**Addendum Number One**

To The Drawings and Specifications for  
**Red Brick (East and West) Restrooms at Lake Afton**  
**Bid # 24-0071, Sedgwick County, Kansas**

Issued: Wednesday, October 30, 2024

**HANNEY & ASSOCIATES ARCHITECTS**

SHEET  
**AS1.3**  
 OF - SHEETS

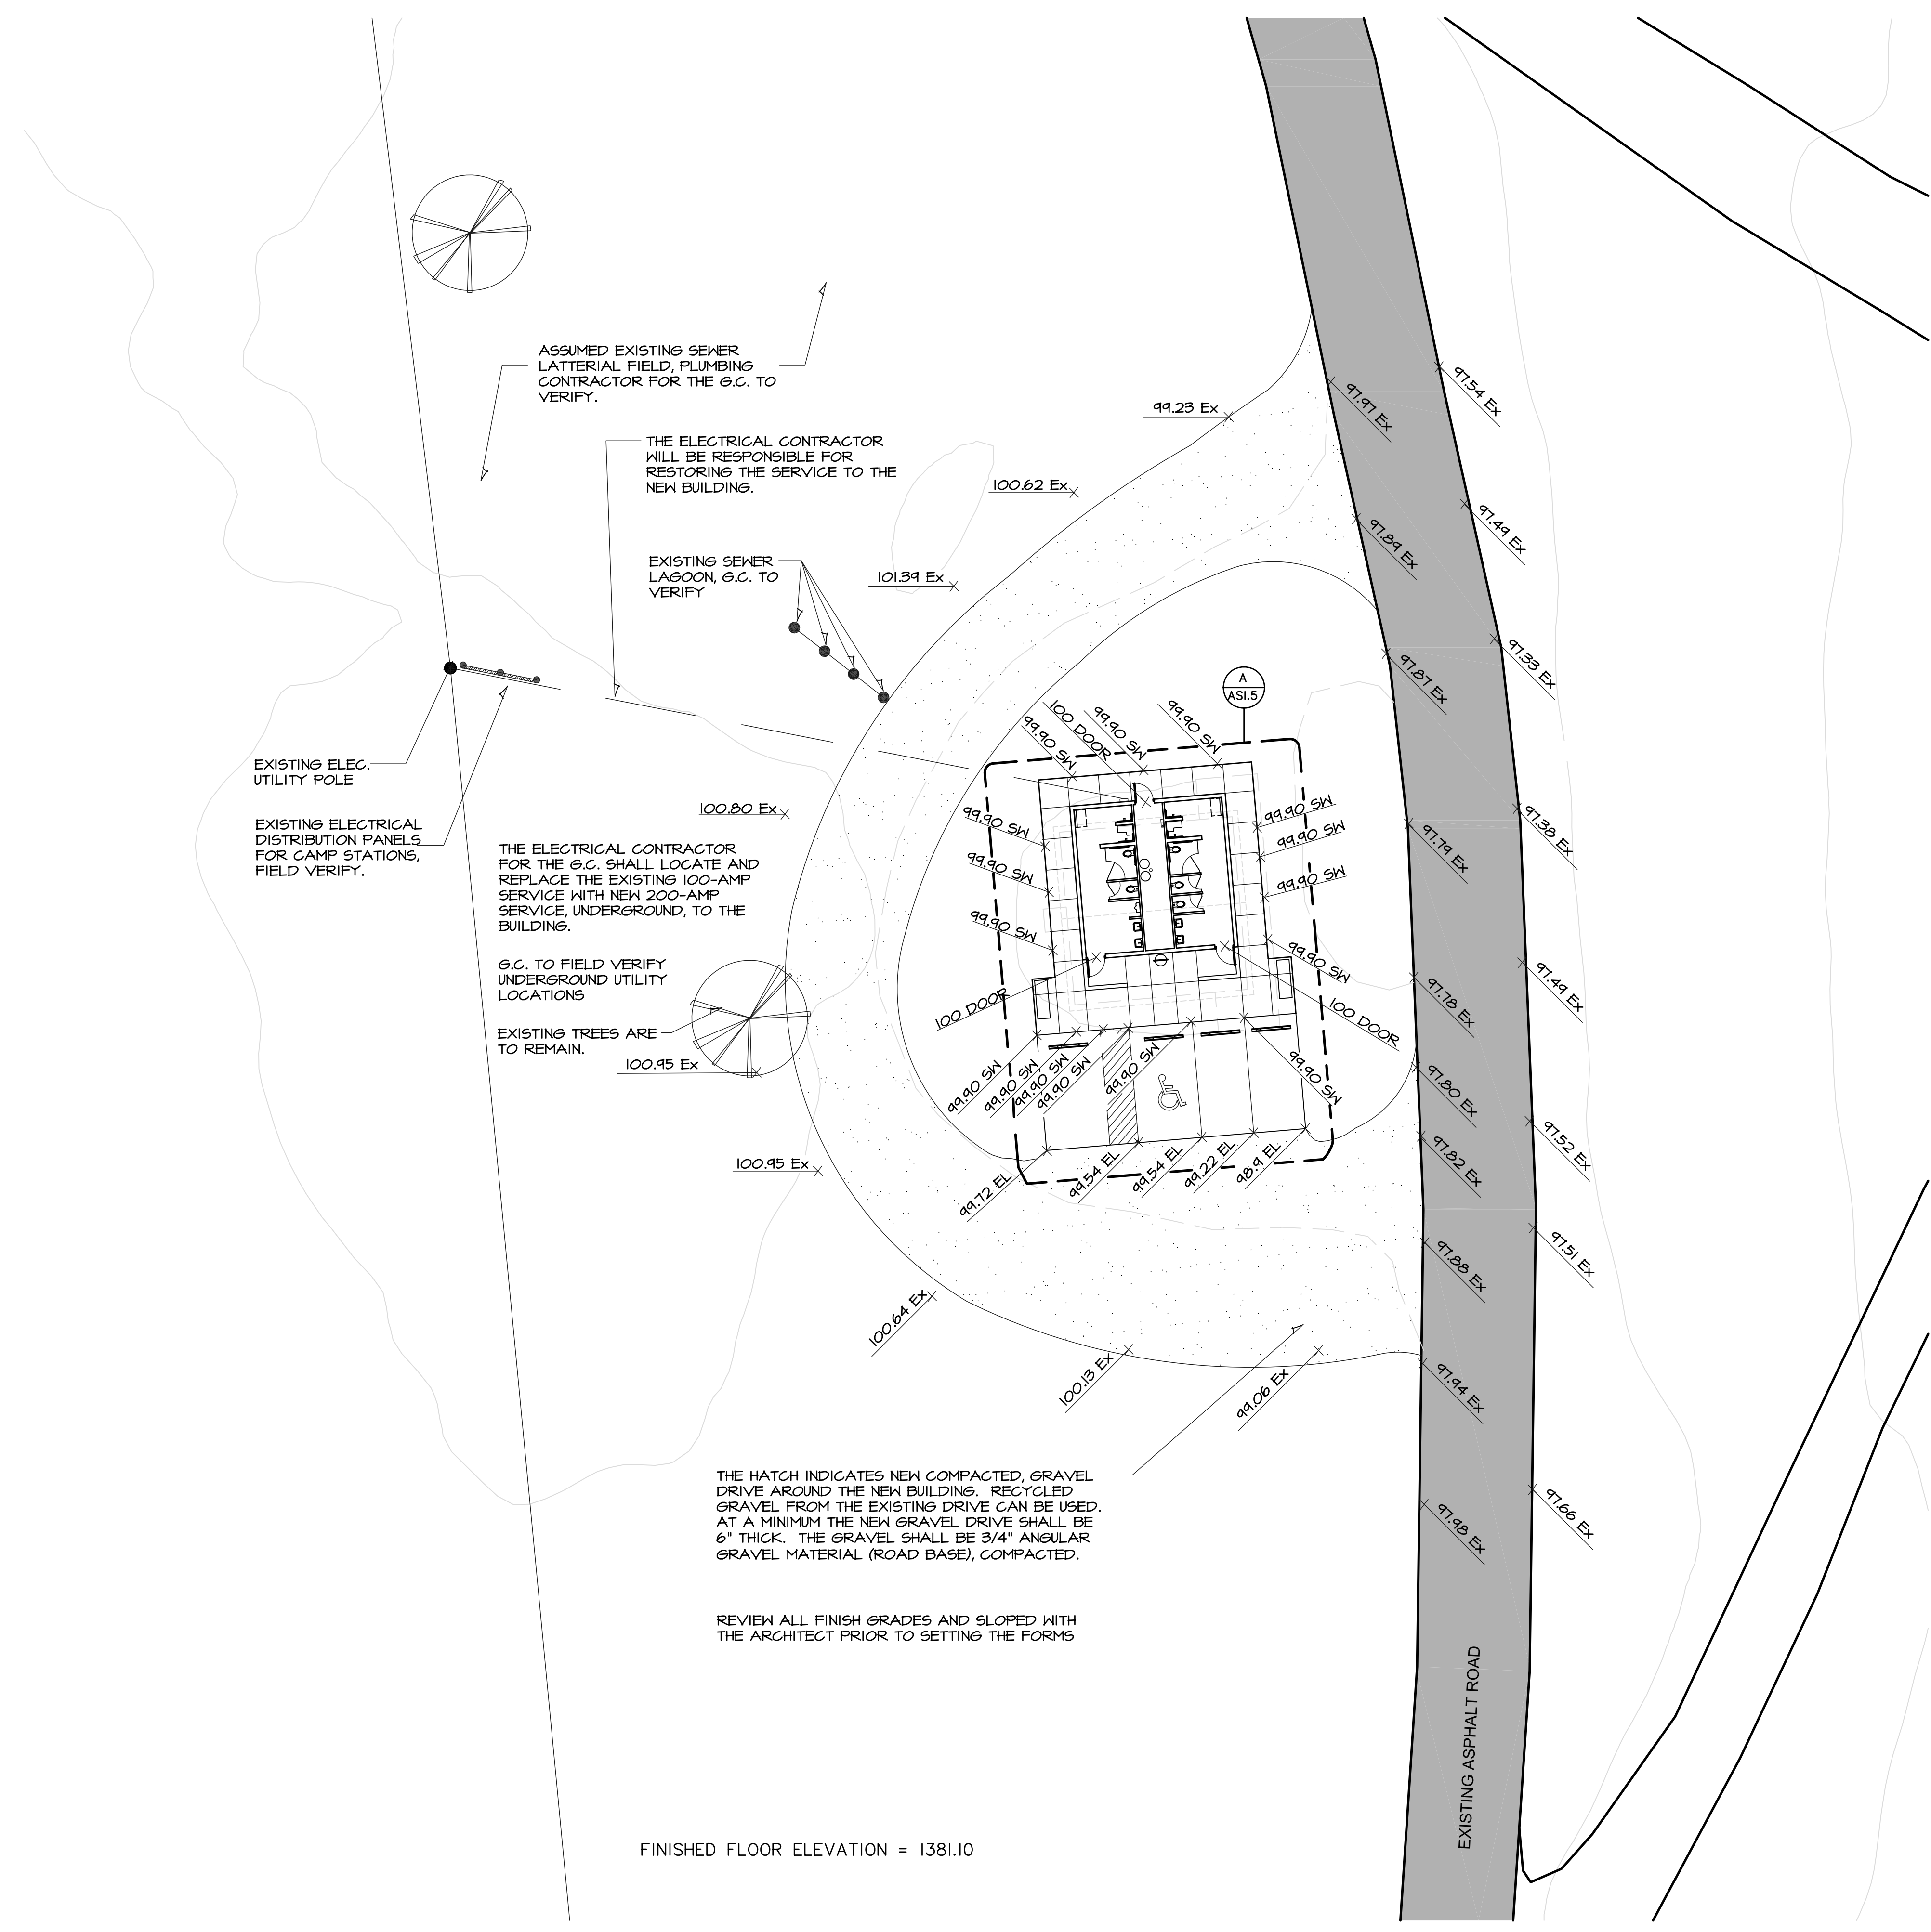
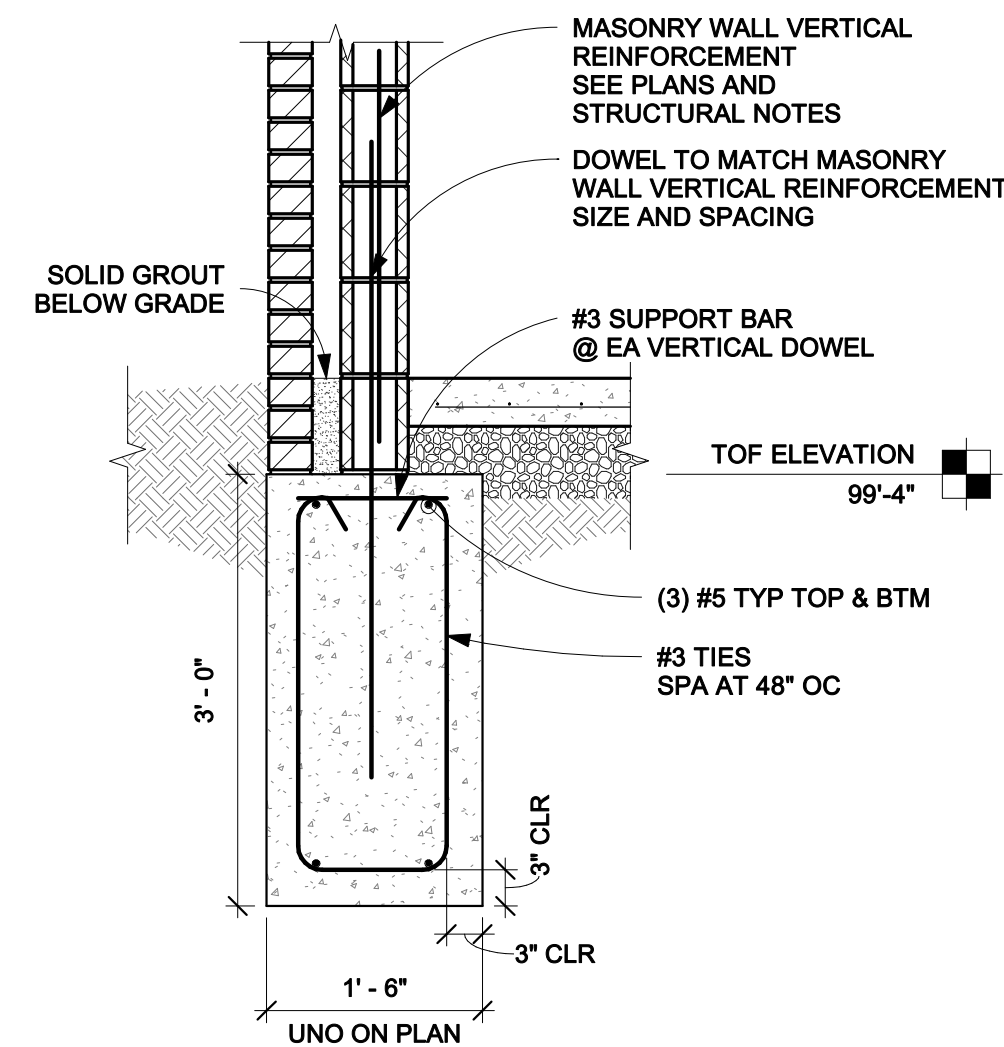
- 3.3 Sheet AS1.3
  - A. This sheet is being reissued with this addendum.
  - B. Spot elevations prepared by K.E. Miller have been added to the Red Brick West site plan.

**S200**

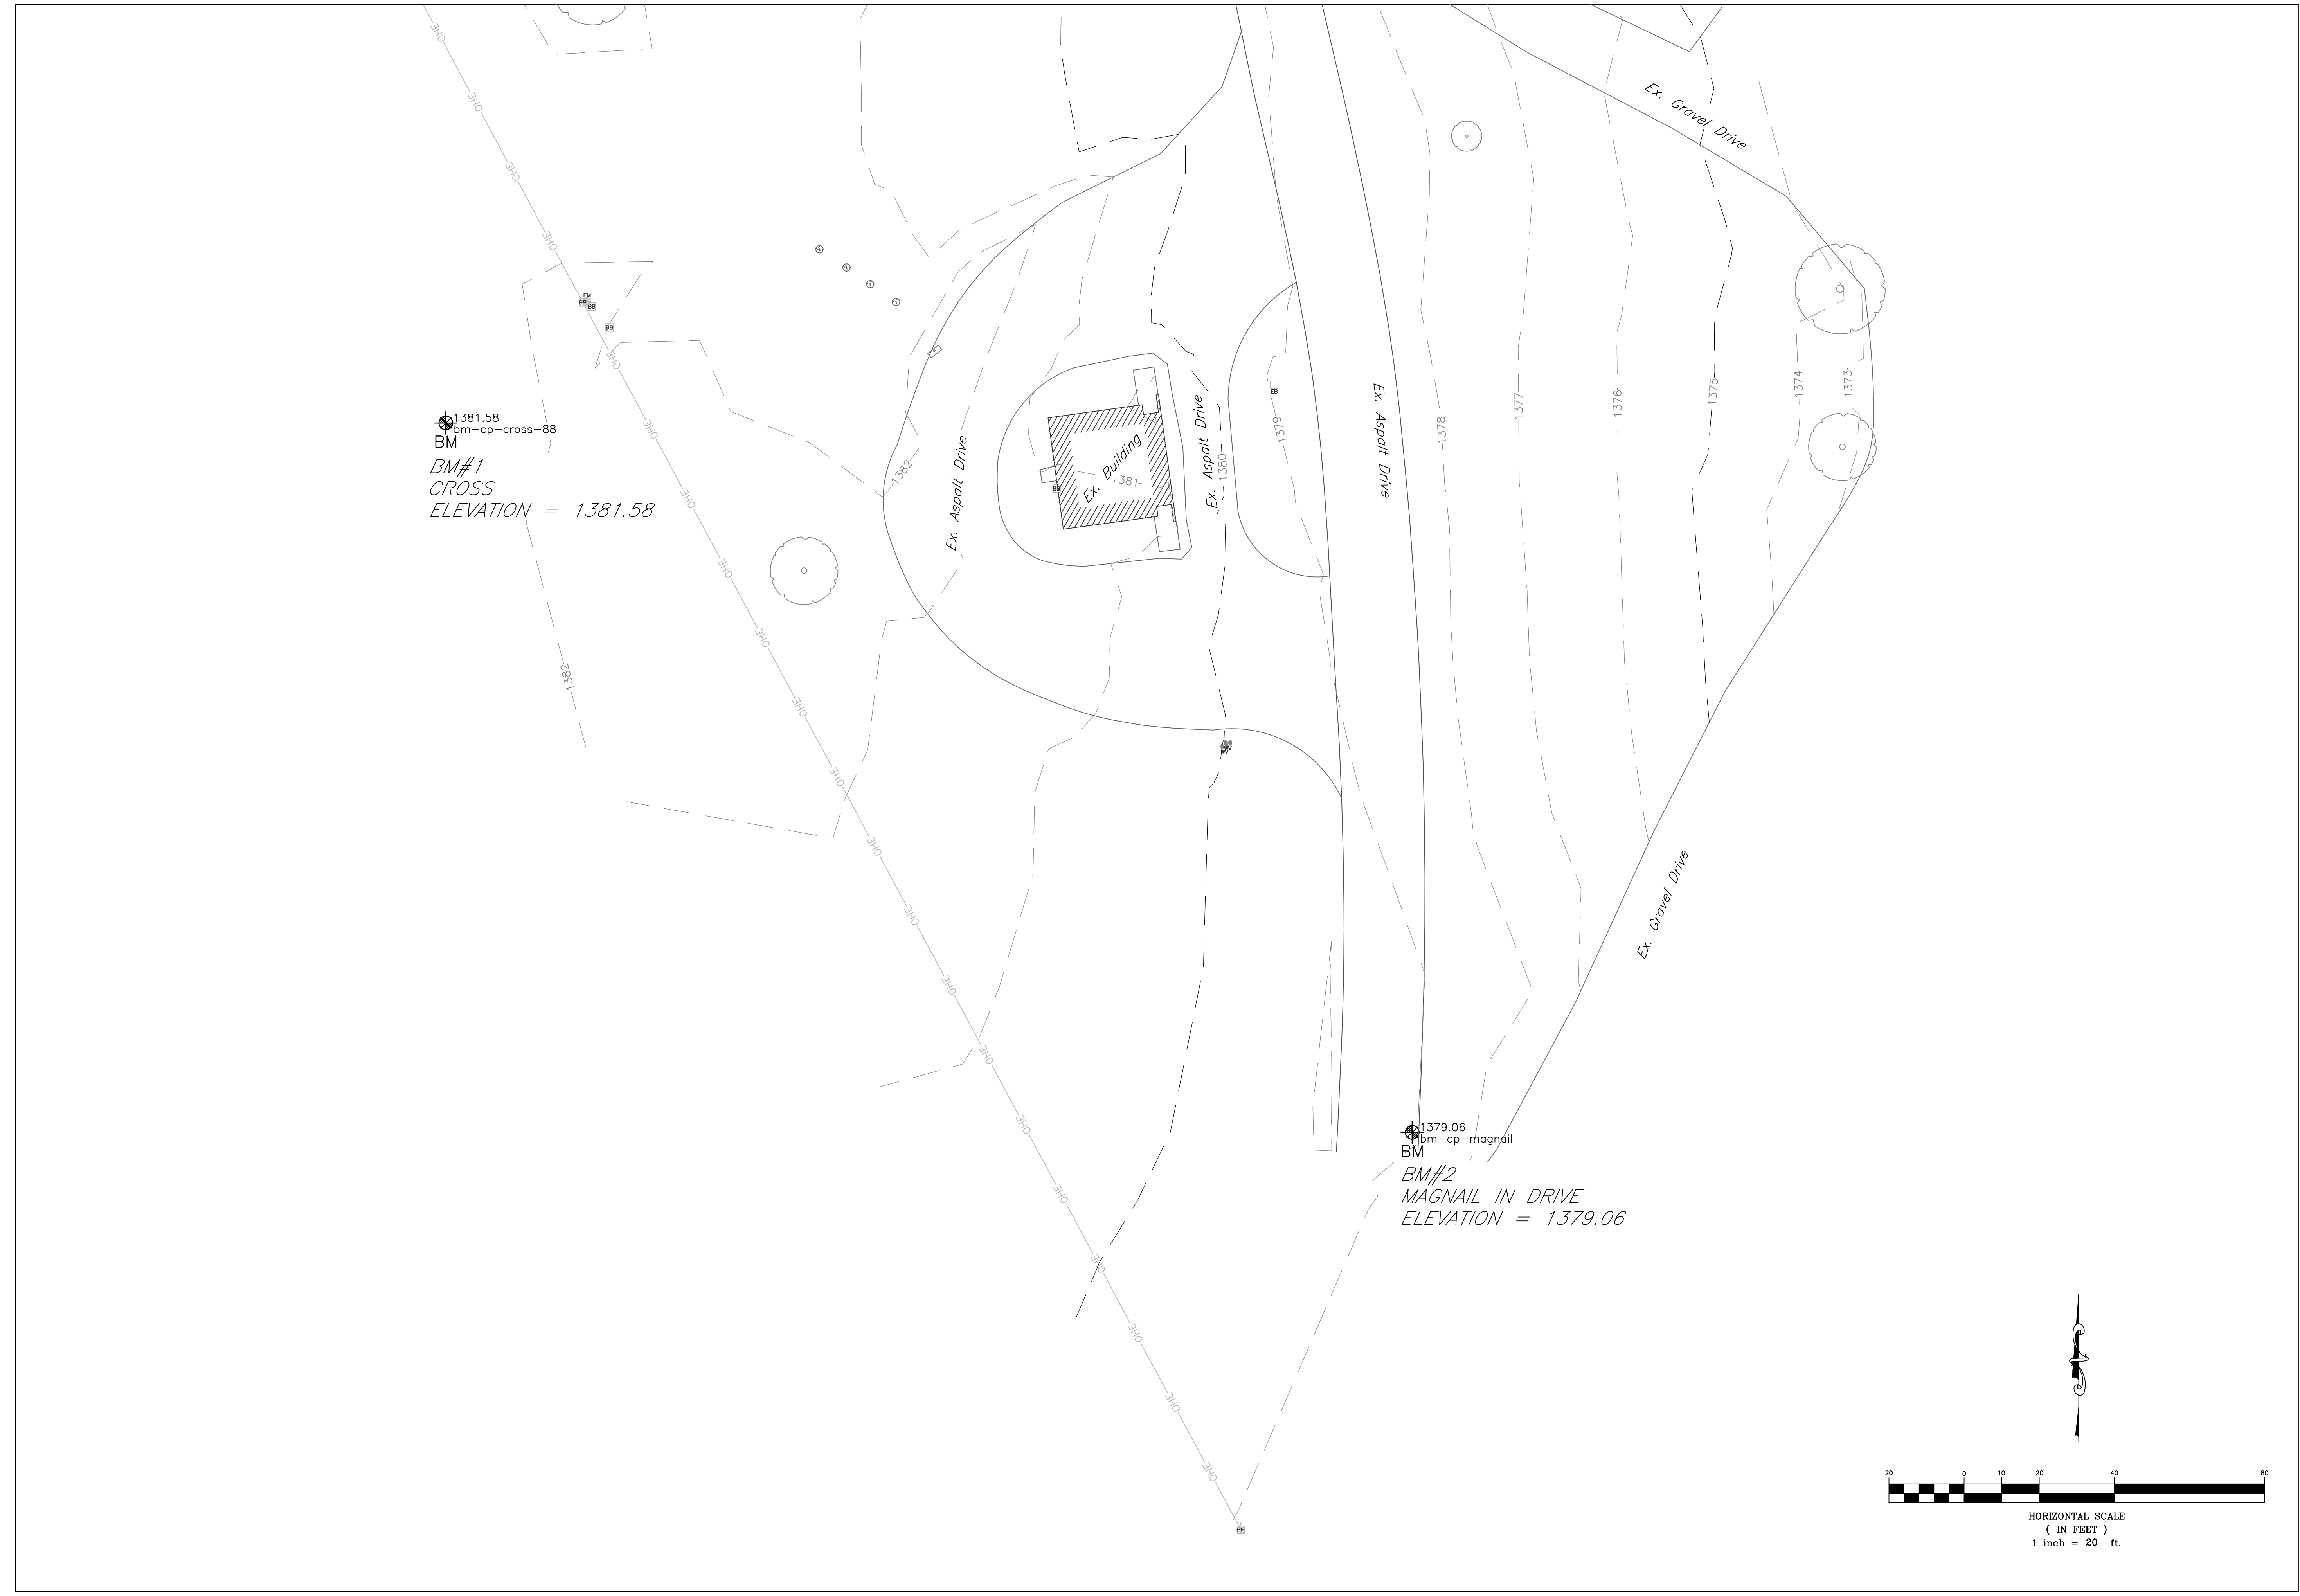
- 3.8 Sheet S100
- A. This sheet has been revised and is reissued with this addendum.
- 3.9 Sheet S200
- A. This sheet has been revised and is reissued with this addendum.

- B. Roof Framing Plan  
The framing over the exterior entrance shall be deleted so the entrance matches what is shown on the architectural plans. This will eliminate two (2) roof trusses, 11-7/8” LVL beam, 2x10 ridge beam, and associated roof deck and roofing.

- C. Outrigger Detail 21
    1. This detail shall be revised to look like detail 5/A5.1 removing the beam, stud wall framing, and trusses as noted in item “B” above for the 8’-0” tall entrance screen walls.

2. Detail 21 shown on the exterior gable end wall shall be deleted. The gable end wall shall be full, reinforced masonry, as shown on the architectural drawings.

- D. Truss Profile Detail 22  
Refer to item 3.7 in this addendum for notes on the truss design.
- 3.10 Survey
- A. Red Brick West: A survey of the site was prepared by K.E. Miller.  
A copy if this survey (showing benchmarks) is included with this addendum.

- 3.7 Sheet A4.2 and S200
- A. The roof trusses shall be designed by a structural engineer licensed in the State of Kansas using the design criteria shown on the Structural Drawings and the slopes shown on the architectural sheets. The size and connects of the members are to be designed by the engineer for the truss fabricator. The structural engineer will be engaged by the truss fabricator.

- B. The design of the trusses shall take into account the design as shown on the architectural drawings – roof/fascia springs from the exterior face of the brick and the interior ceiling springs from the interior wall. A horizontal ledge on top of the interior wall is not acceptable. Please refer to detail 3 on sheet A2.2.

- C. There are several possible solutions, but the end result must follow the design criteria noted above. The truss shown on the structural drawings does not follow the architectural design criteria and shall be modified by this addendum.
